SOUTH BATTERY PARK CITY RESILIENCY

CB1 UPDATE

MARCH 21, 2022

EXPOSED FLOODWALL DESIGN DRIVERS

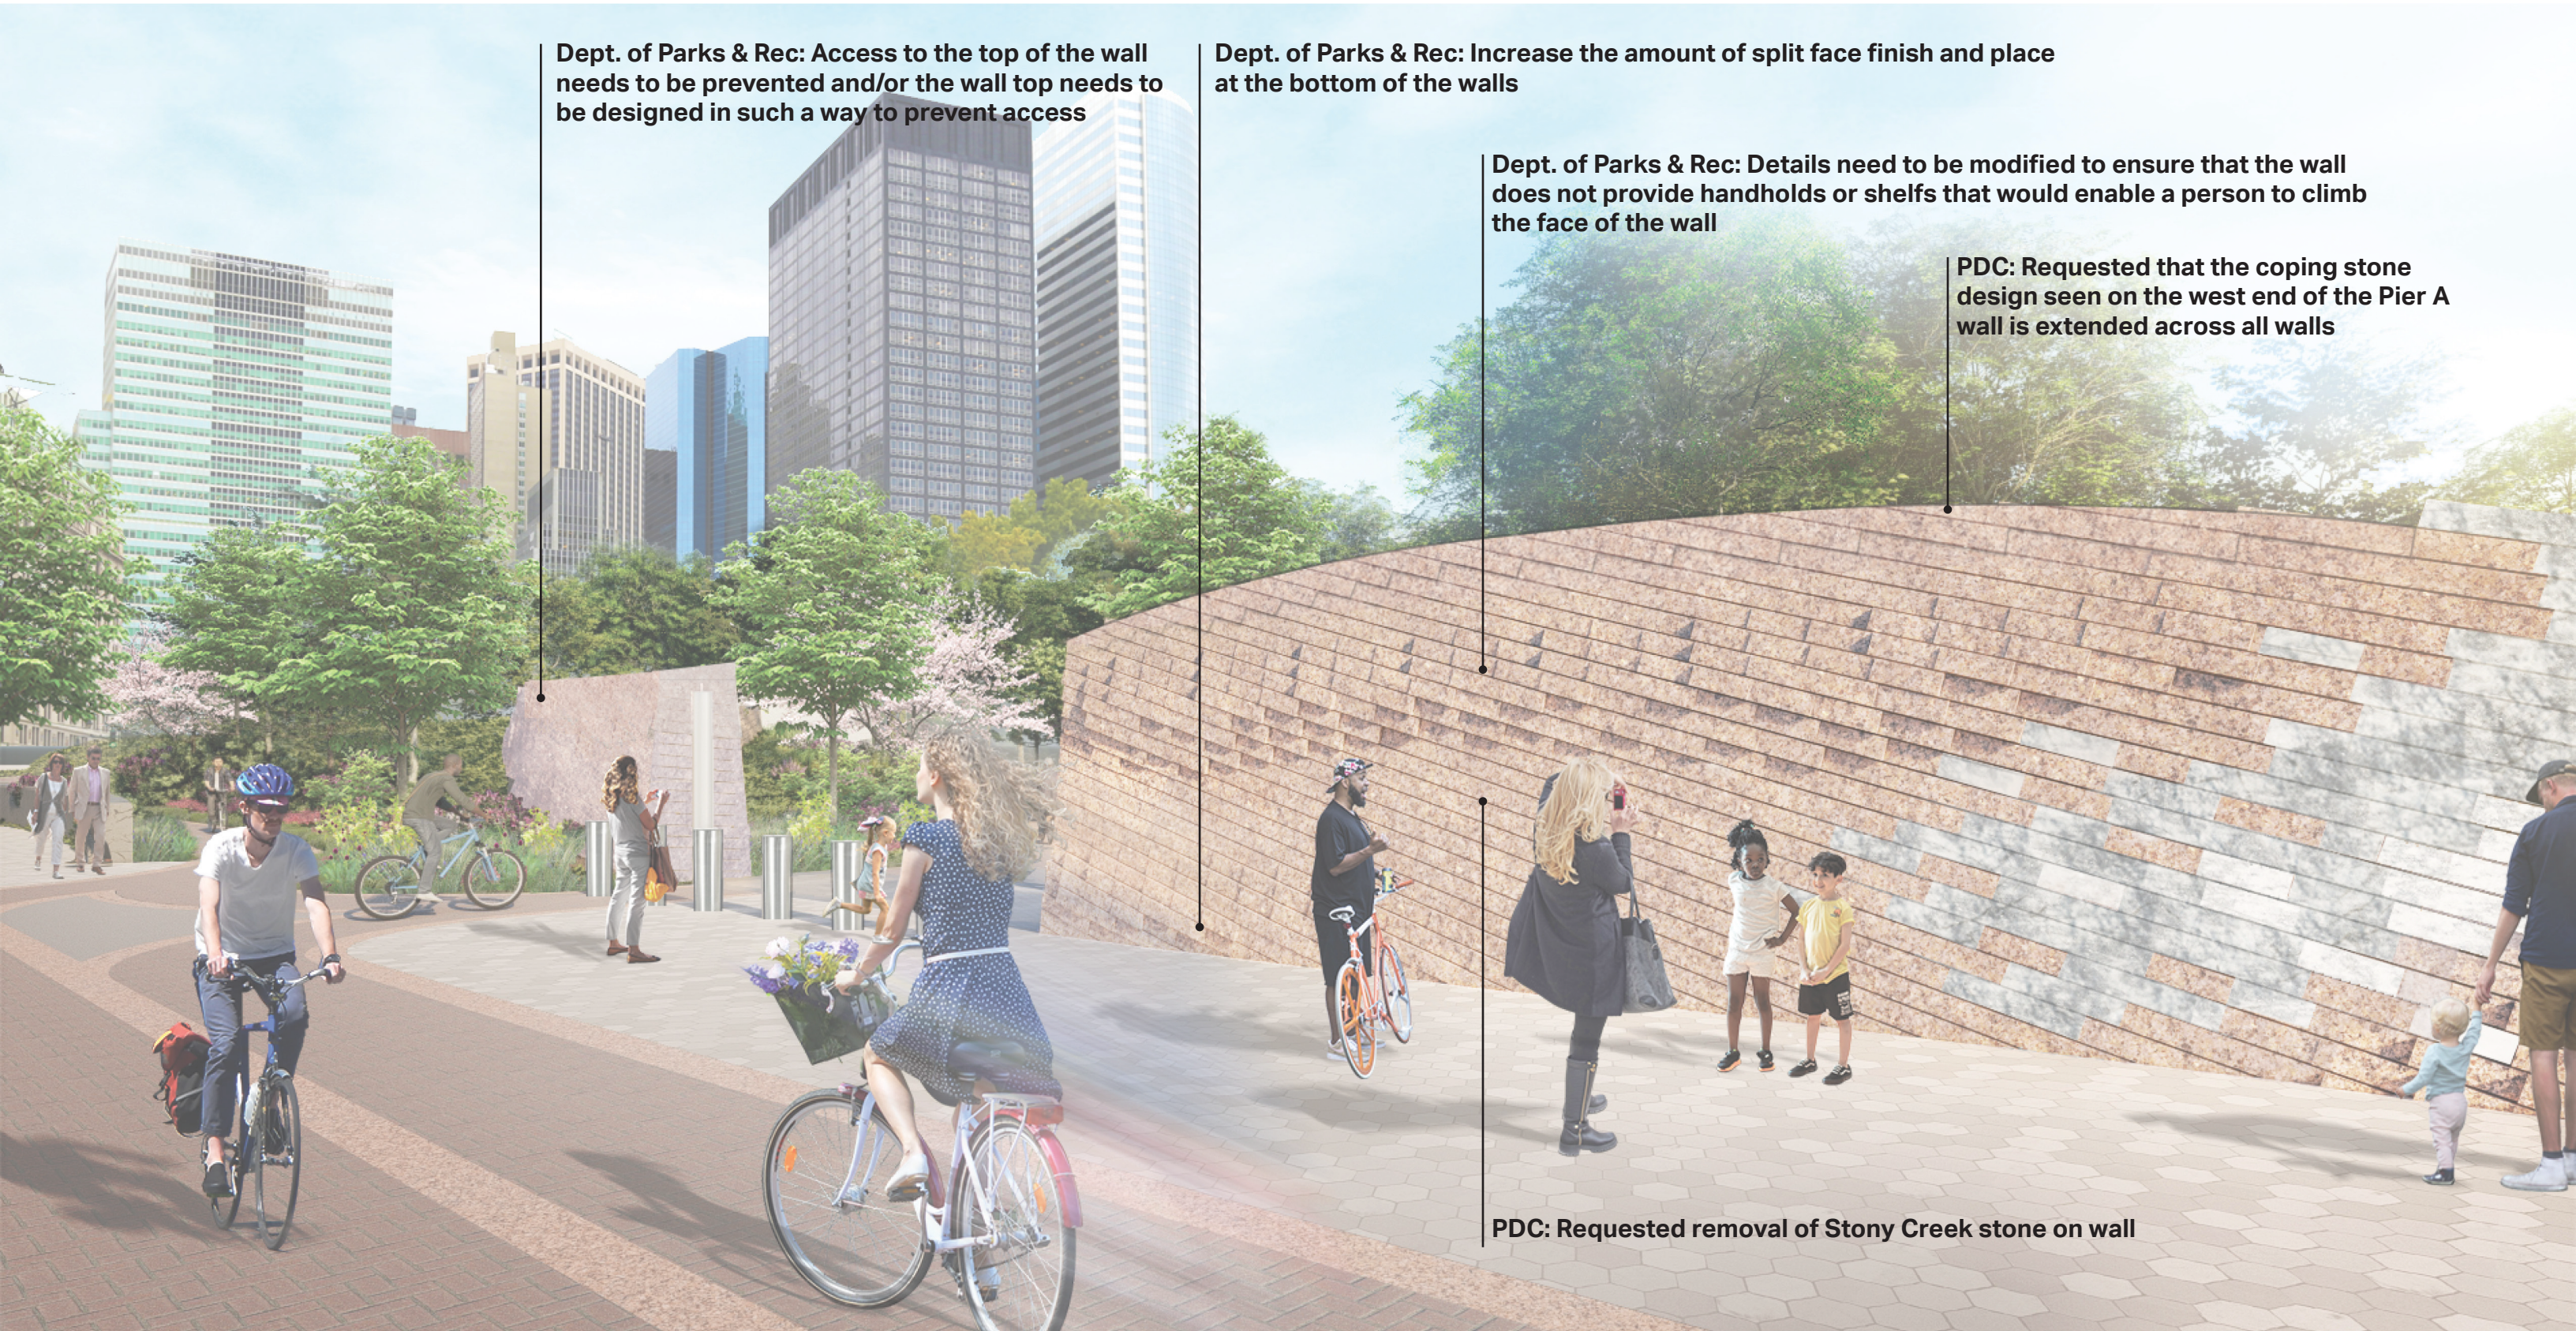
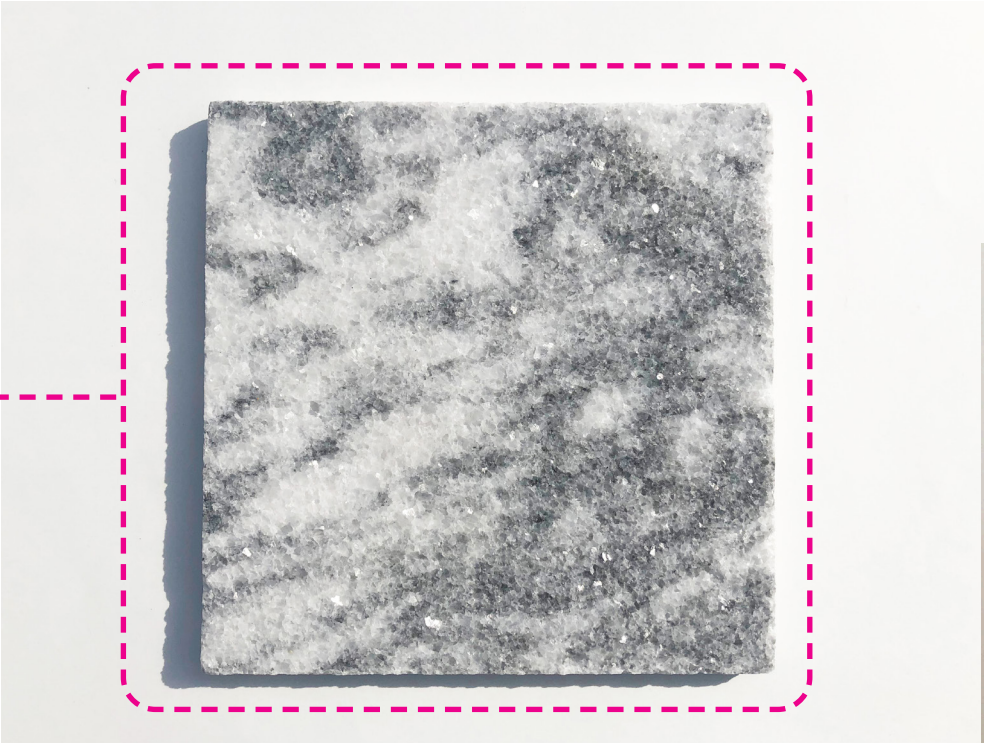
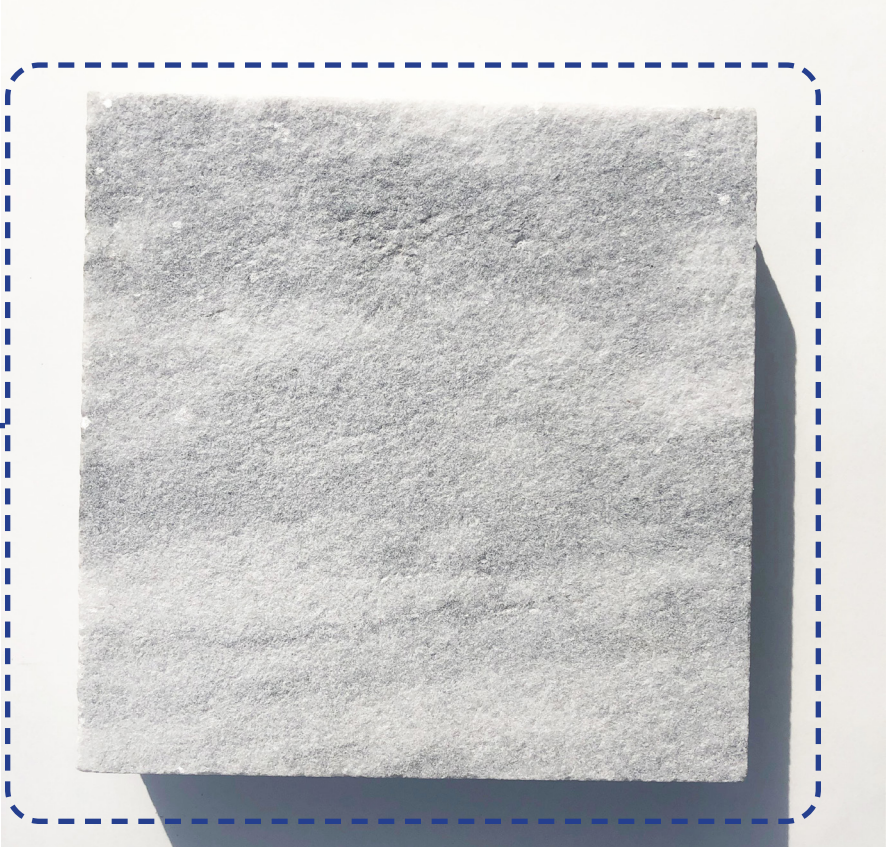
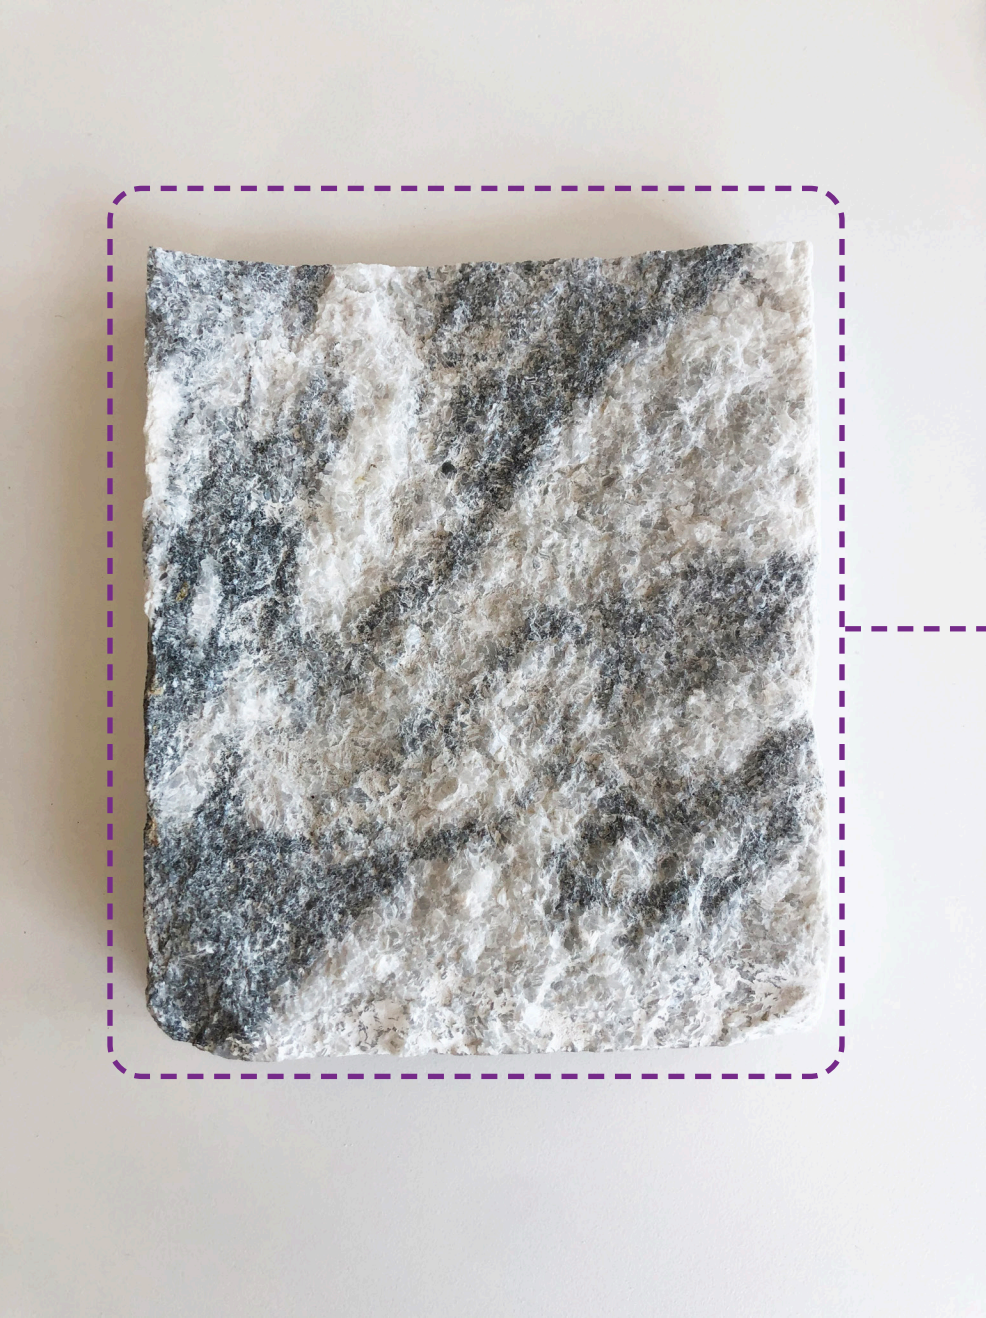
Dept. of Parks & Rec: Access to the top of the wall needs to be prevented and/or the wall top needs to be designed in such a way to prevent access

Dept. of Parks & Rec: Increase the amount of split face finish and place at the bottom of the walls

Dept. of Parks & Rec: Details need to be modified to ensure that the wall does not provide handholds or shelves that would enable a person to climb the face of the wall

PDC: Requested that the coping stone design seen on the west end of the Pier A wall is extended across all walls

PDC: Requested removal of Stony Creek stone on wall
